REMARKS

Summary of Office Action

AMENDMENTS TO THE DRAWINGS

Fig. 1

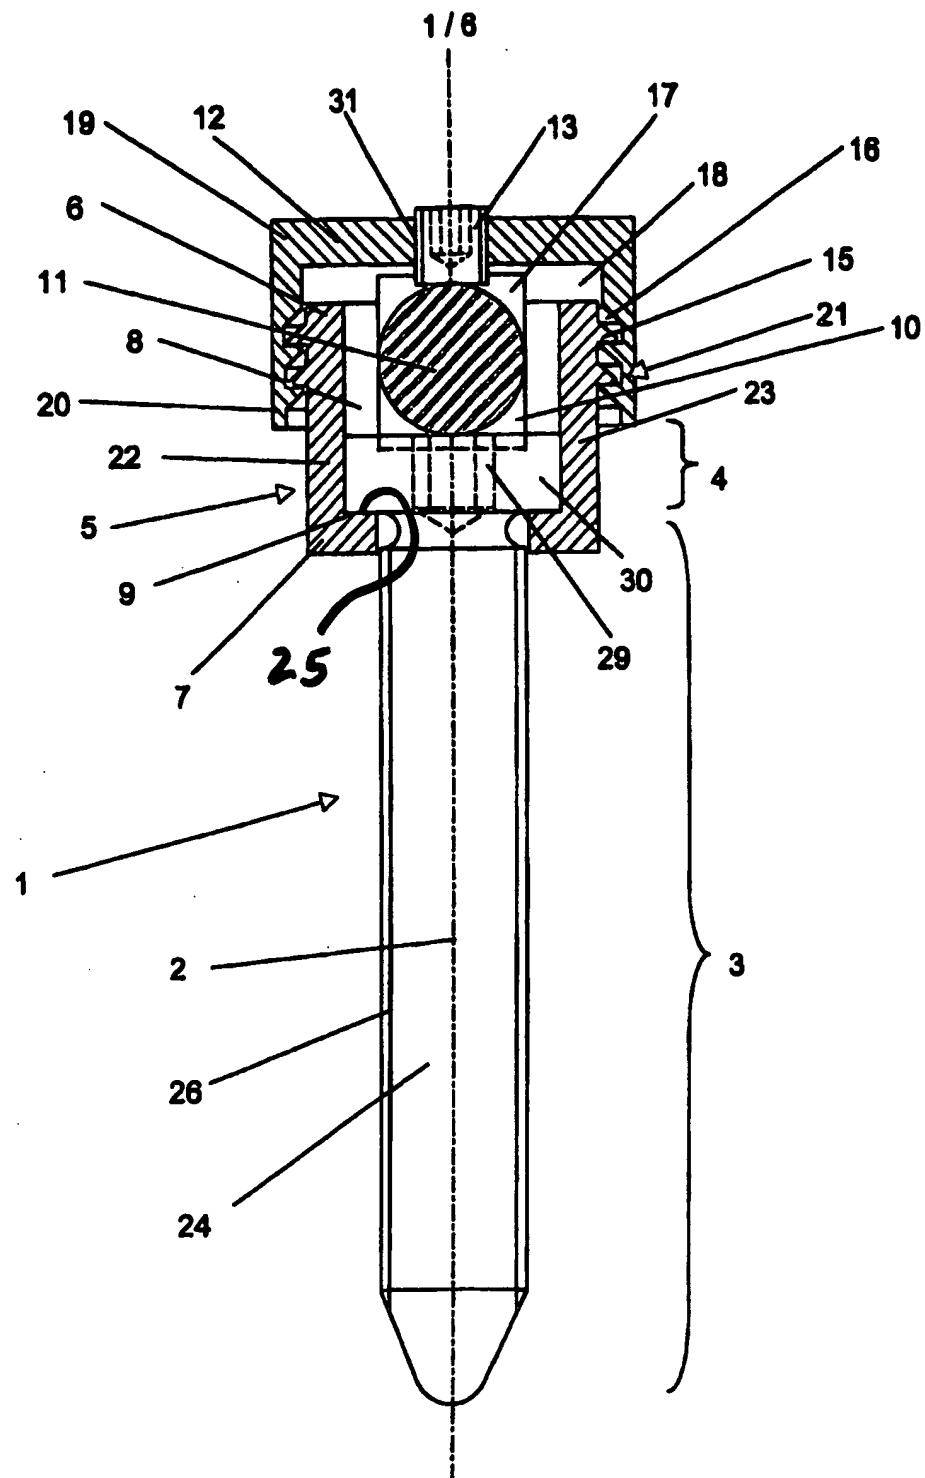
The Examiner also objected to the drawings for not including reference numerals mentioned in the specification. In particular, reference numeral 25 is mentioned in the specification (*see, e.g.*, paragraph 21 of the substitute specification: “bearing surface 25”), but is not included in the drawings.

Applicant has amended FIG. 1 to include reference numeral 25 with a lead line touching the bearing surface of shoulder 9, as described in paragraph 21 of the substitute specification.

- add reference numeral "25" to FIG. 1; and
- remove reference numerals "37" and "38" from FIG. 6.

Fig. 6

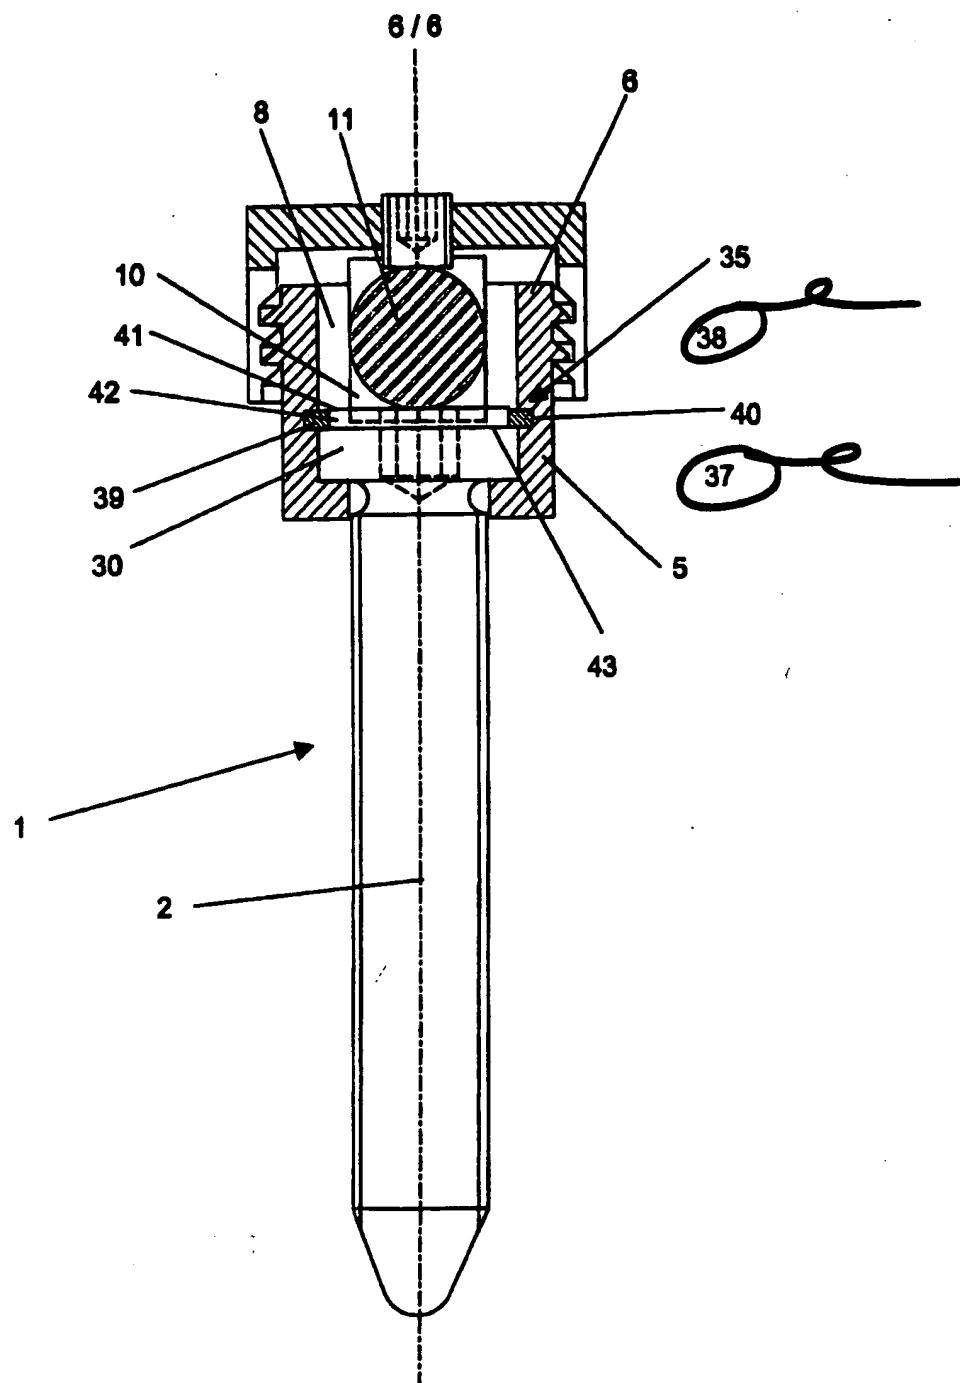
The Examiner further objected to the drawings for containing reference numerals 37 and 38 in FIG. 6 that do not point to anything (i.e., no lead lines/arrows).

And applicant has amended FIG. 6 to remove reference numerals 37 and 38, which refer to features shown in FIG. 5, not FIG. 6.
